Value Planning Study

Final Report

California Department of Water Resources Through Delta Facility *Sacramento, California*

June 2007

Alternative No.: DF-27

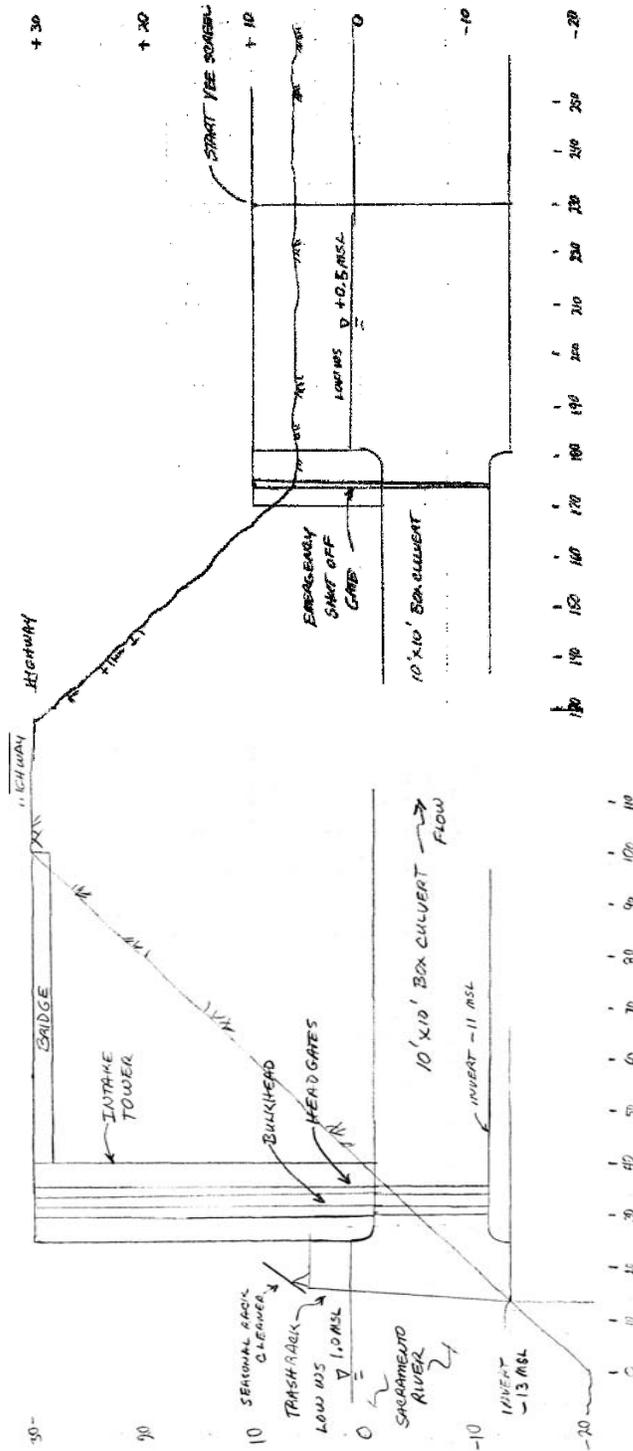
Provide trashracks and head gates on the river side of the levee and locate the intake structure on the land side

This approach also allows the canal fish screens and pump station to be isolated from the river for maintenance. Extra stop logs and lifting mechanisms would not be required.
